ANNEXURE A1

Proposed Designation and Consent Conditions

23 June 2011

This shows amendments from the “red book” set of Proposed Conditions dated 25 March 2011. The parties’ experts’ responses (13 May 2011) as directed are shown in purple line changes, and amendments made by the Board with its draft Report (25 May 2011) are shown in red line changes.

Figure DC.B – OPW2 Southern Ventilation Buildings and Stack

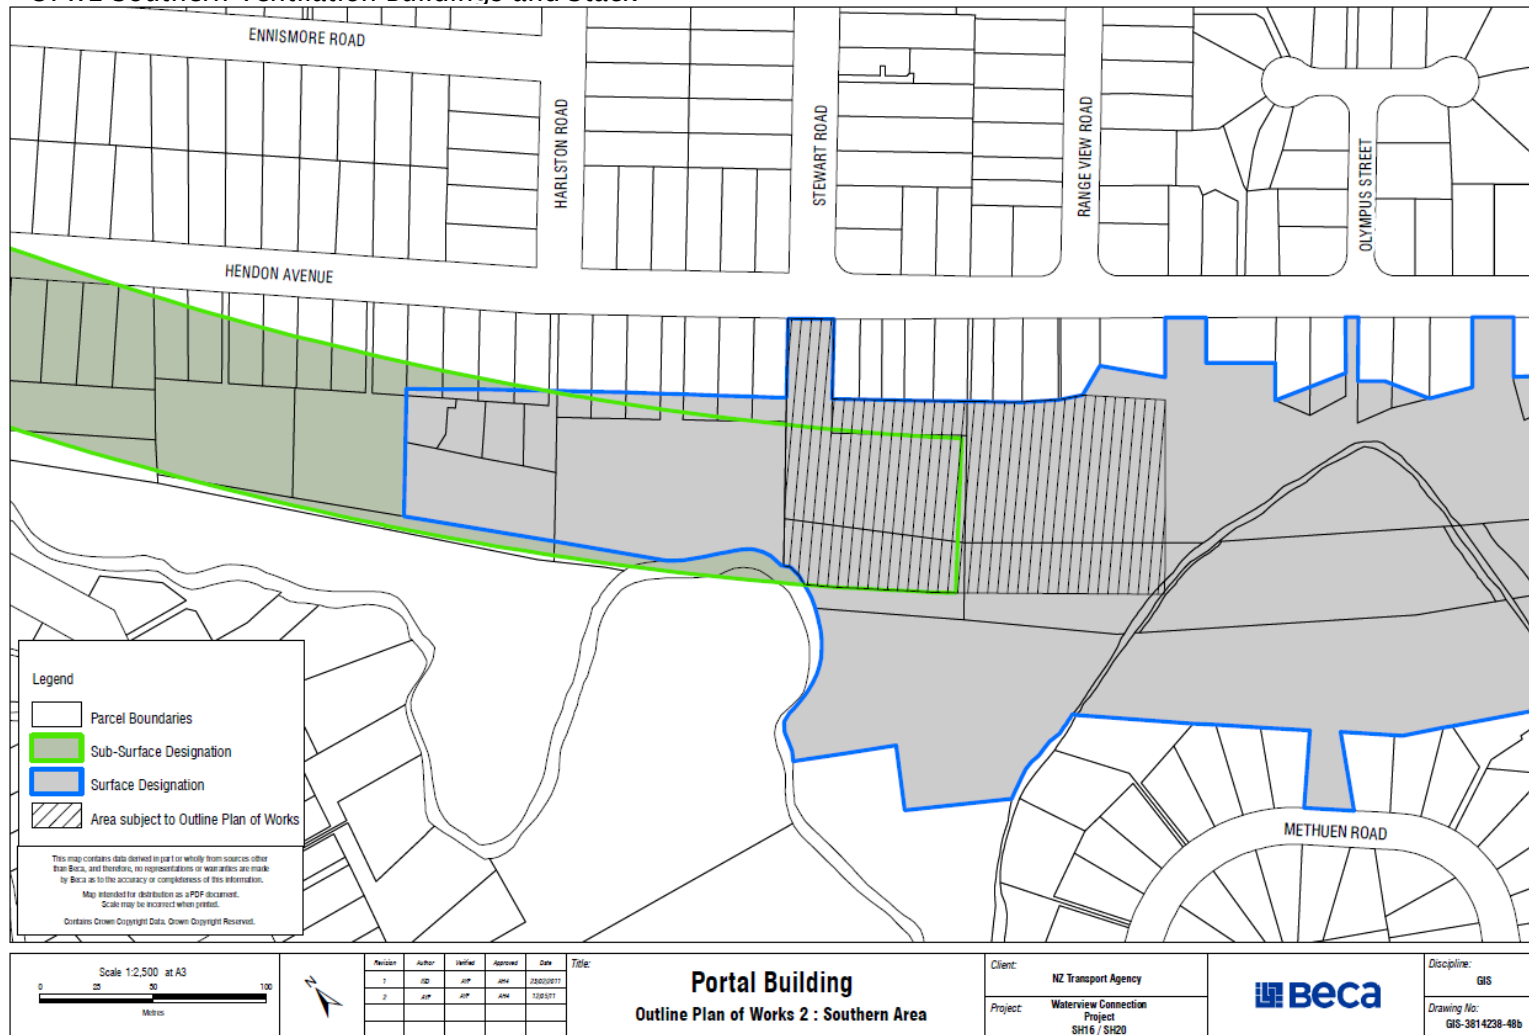
DC.9	<p>Outline Plan of Works for the Southern Ventilation Building, <u>Control Building and Stack</u> (which include the southern ventilation building and control building but preclude the</p>

~~inclusion or attachment of equipment for any activity unrelated to the tunnel operation and its ventilation system~~ and Ventilation Stack (OPW2) (Refer Figure DC.B).

- (a) Retention of the same building / structural components underground as per the revised Drawing Set F.8, specifically Drawings of Vent South Option 003 / 003A (refer Schedule A, Row 9);

- (b) Creation of an above ground building ~~slim, linear plan~~ arrangement that maximises the separation of the buildings from the houses on Hendon Avenue to the east and the pedestrian / cycle way to the west;

- (c) The location of facilities, accessways, parking and manoeuvring areas to be in general accordance with the revised Plans of Drawing Set F.8, specifically Drawings of Vent South Option 003 / 003A (refer Schedule A, Row 9), providing for a subject however to that relating to a shift of between 70 – 80m to the south east from the position shown in the application documents, the final decision within that 10m range to be taken by the NZTA, to the approval of Major Infrastructure Team Manager, Auckland Council, after consultation with the Community Liaison Group for Owairaka established under Condition PI.5;
